Access Compliance Report Public Rights-of-Way (Curb Ramps)

Main Street: DRUID_LN Cross Street: SILVER_FOX_RD Location: NW

ADA ID: RPRK211206170449 Ramp Type: Type 1 - Perpendicular Diagonal Initial Pass/Fail: Pass Overall Compliance: No Severity Score: 15

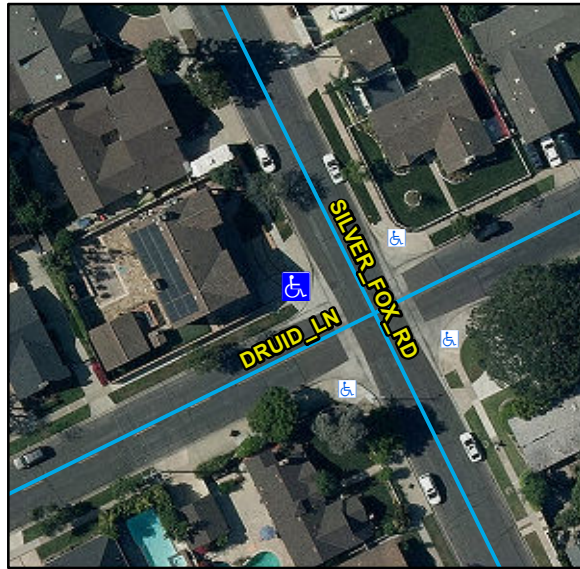
R304.2.2, R204.3, R305, R304.5.4, R304.5.3, STD 1115

Compliance	Description	Data	Compliance	Description	Data
N/A	Ramp Length (in)	80	N/A	Flare Type LT	
Yes	Ramp Width (in)	50			Sloped
Yes	Ramp Run Slope (%)	7.5	N/A	Flare Slope LT (%)	1.8
Yes	Ramp Cross Slope (%)	1.1	N/A	Flare Traversable LT	No
N/A	Landing Present	Yes	N/A	Flare Type RT	
N/A	Landing Length (in)	48			Sloped
Yes	Landing Width (in)	50	N/A	Flare Slope RT (%)	6.8
Yes	Landing Run Slope (%)	2	N/A	Flare Traversable RT	No
Yes	Landing Cross Slope (%)	2	No	DWS Provided	No
N/A	Landing Movement Obstructed?	No	N/A	DWS Contrast	N/A
	Landing Movement Type	N/A	N/A	DWS Length (in)	N/A
N/A	Landing Shared	No	N/A	DWS Full Width	N/A
N/A	Clear Space	Yes	N/A	DWS Offset Left (in)	N/A
N/A	Clear Space To Crosswalk (in)	48	N/A	DWS Offset Right (in)	N/A
N/A	Marked Crosswalk 1	No	N/A	Marked Crosswalk 2	No
	Crossing 1 Direction	S		Crossing 2 Direction	E
	Marked Crosswalk 1 Width (in)	N/A		Marked Crosswalk 2 Width (in)	N/A
N/A	Ramp Inside Crosswalk 1	N/A	Yes	Ramp Inside Crosswalk 2	N/A

Crossing 1 Slope (%)	5.6		Crossing 2 Slope (%)	8.1
	Crossing 1 Cross Slope (%)	2.5		Crossing 2 Cross Slope (%)	1.8
Yes	Gutter Ponding	No	No	Curb Slope	5.1
Yes	Gutter Lip Height (in)	0		Road Run Slope (%)	1.3
No	Gutter Run Slope (%)	5.3		Road Cross Slope (%)	3.5
No	Gutter Cross Slope (%)	3			
Yes	Overall Surface Condition: Acceptable		No	Perp Joint Present	No
	Cross Gutter Present?	Yes		Spandrel Present?	Yes
	Replace Cross Gutter?	No		Replace Spandrel?	No

Remove & Replace Curb Ramp With Two New Directional Ramps or Equivalent. Remove & Replace Gutter.
